BOARD ACTION REPORT – APPEALABLE ITEM

Project Name: 215 NE 7th Avenue

SITE PLAN REVIEW AND APPEARANCE BOARD STAFF REPORT

File No.: 2019-001-
SPM-SPR-CL5

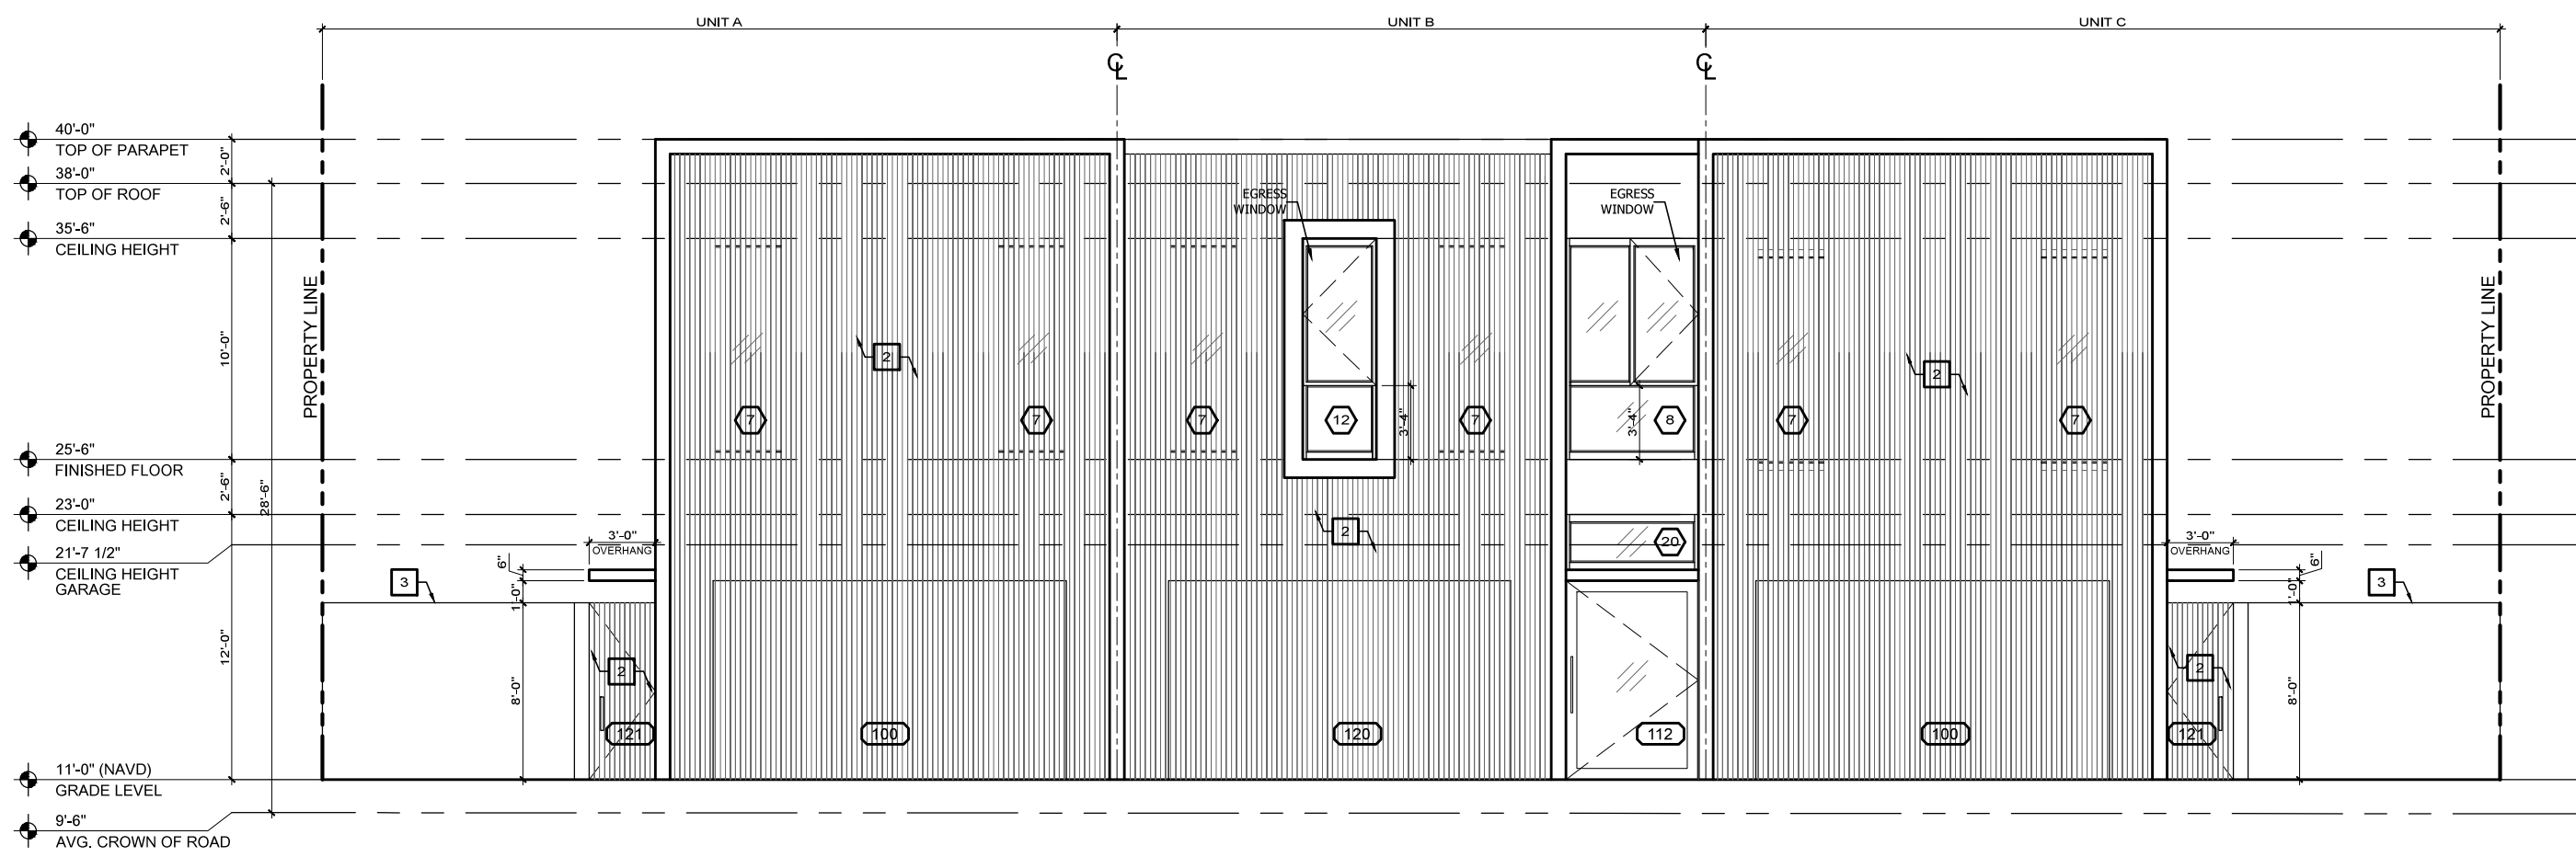
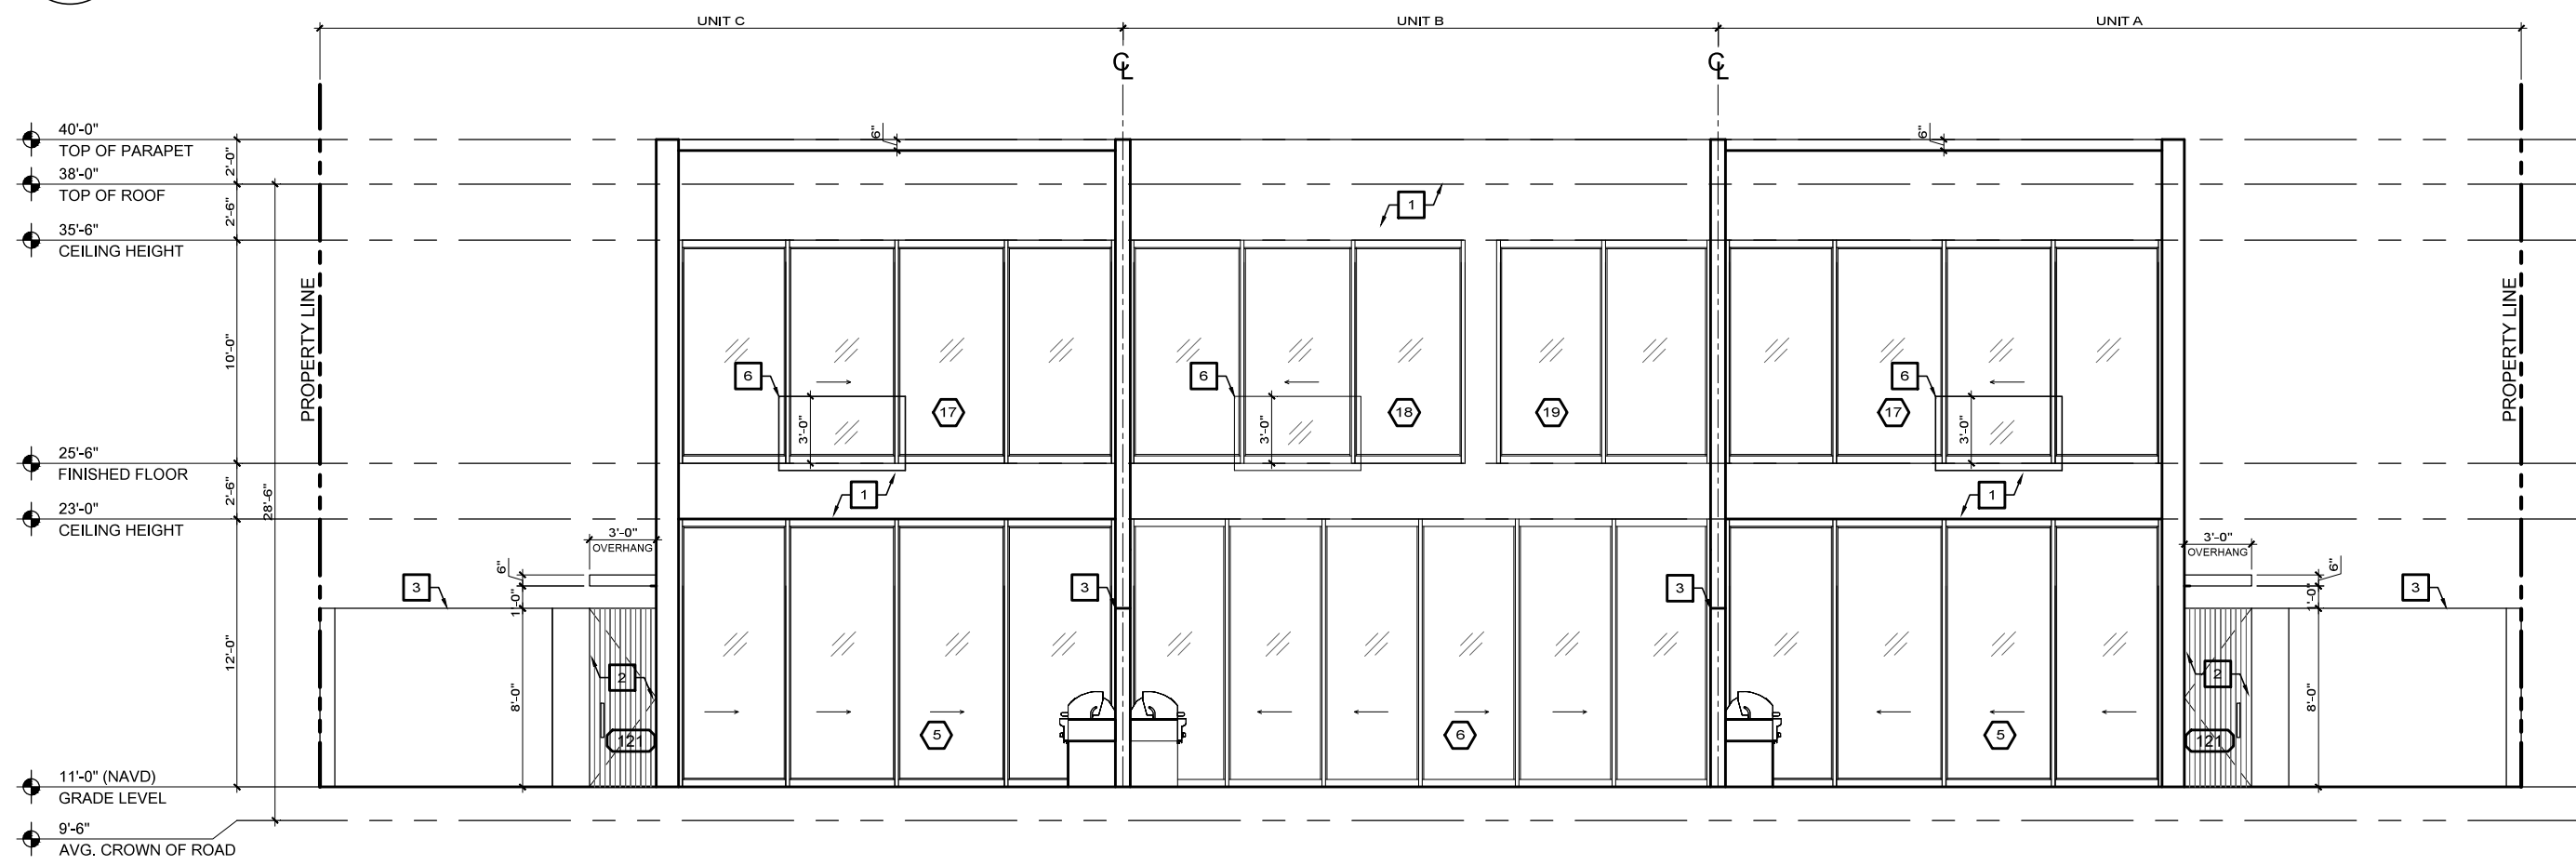
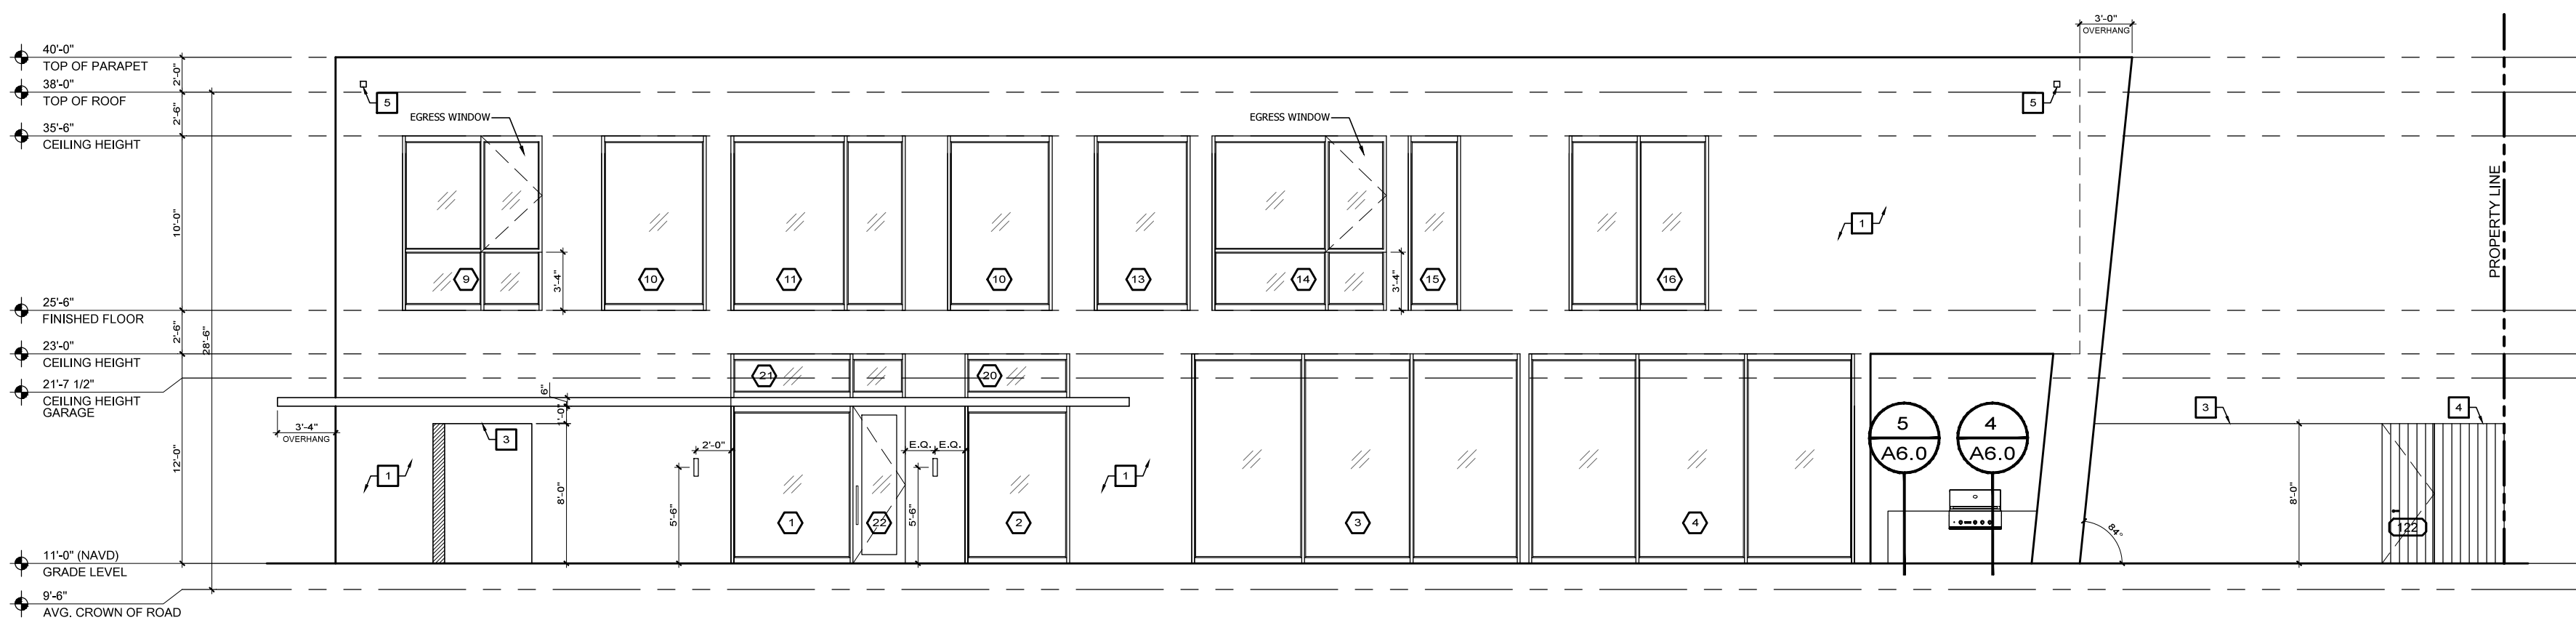
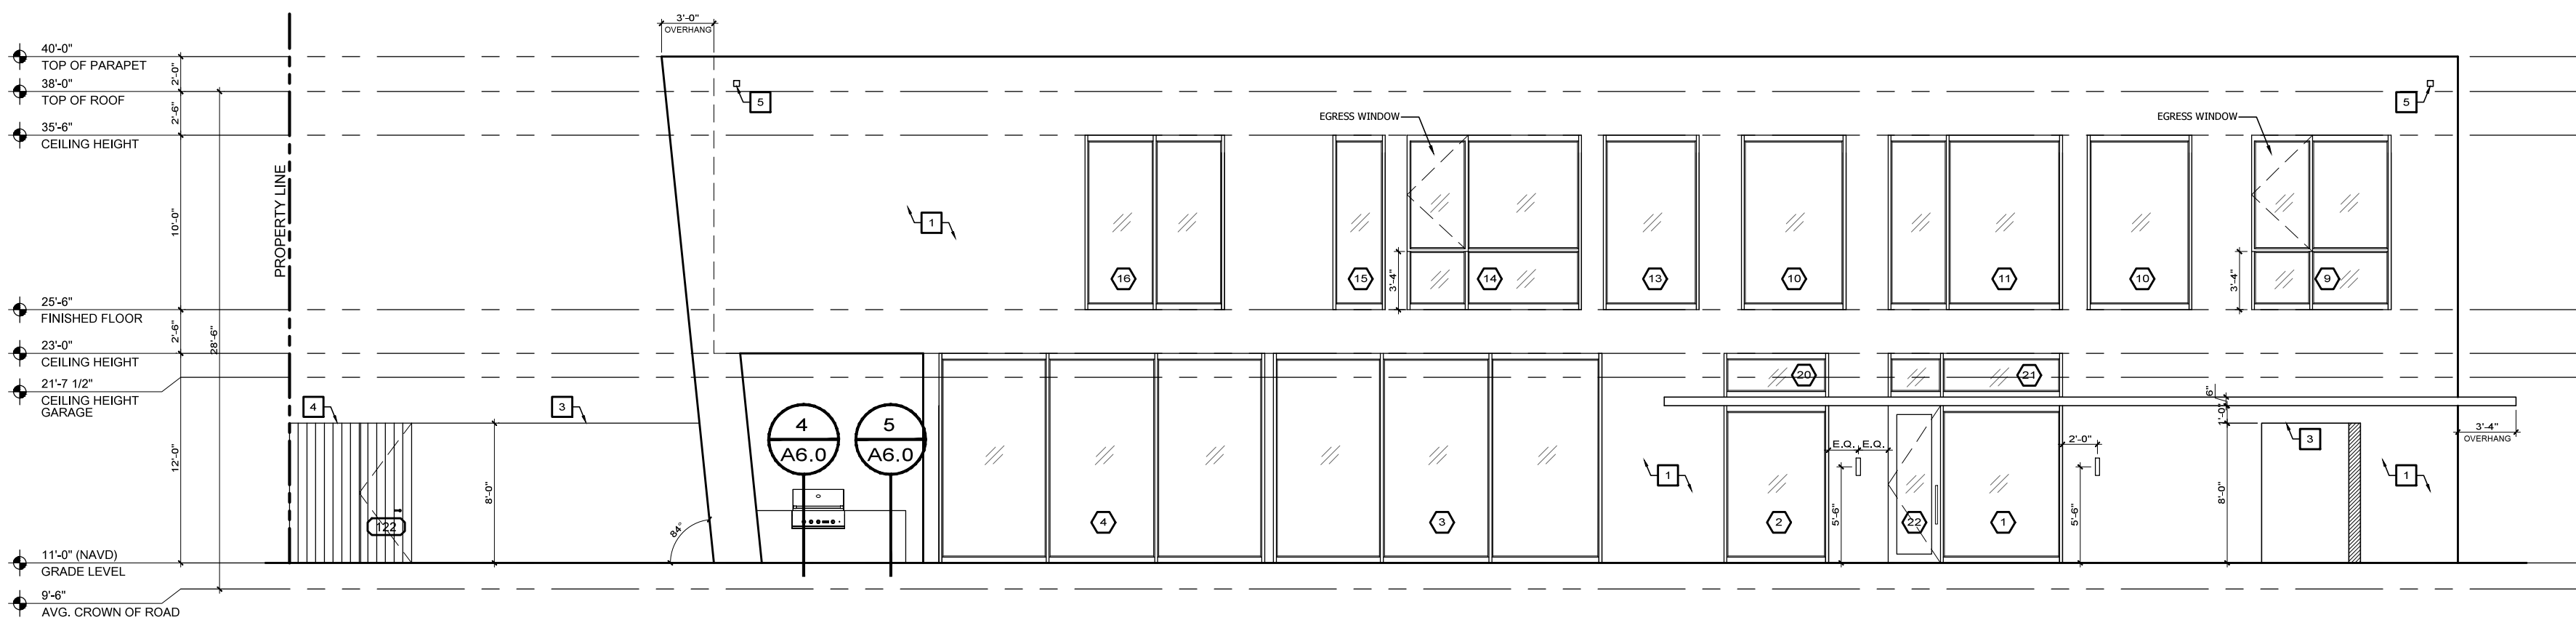
Internal Adjustment approved (7-0) Site Plan approved (6-1 John Brewer dissenting) Landscape Plan approved (5-2 John Brewer and Price Patton dissenting) Architectural elevations denied (2-5).

Board comments were not supportive of the requests for the architectural plan. Several of the board members expressed concern that another Masonry Modern type development was being developed on this street and that maybe a text amendment to the LDR’s was in order.

Several members of the community spoke against the project due to the proposed landscaping and architectural elevations.
